**The Victorian Government Submission to
the *proposed Basin Plan***

WHOLE OF VICTORIAN GOVERNMENT SUBMISSION

APRIL 2012

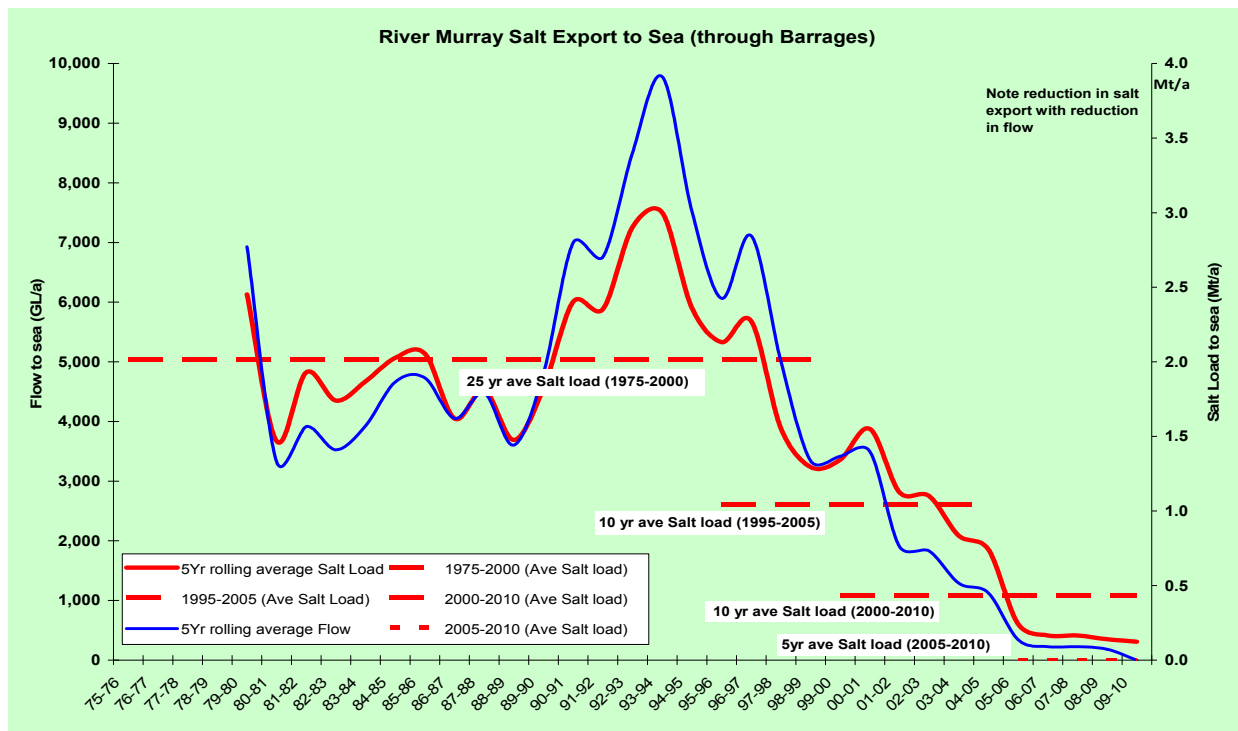
A recent South Australian Government report shows that the tonnes of salt moving across the barrages remained fairly constant for 30 years from 1978 until 2000 (see graph below).

When flows across the barrages declined dramatically from 2000 onwards, so too did the tonnes of salt crossing the barrages. Put simply, the salt load reaching the Southern Ocean was highly correlated with the volume of water also reaching the Southern Ocean.

The information in the South Australian Government report, as well as Figure 68 in the *Hydrologic Modelling Report* shows that the Salt Load Target is not met in a series of years coinciding with drought.
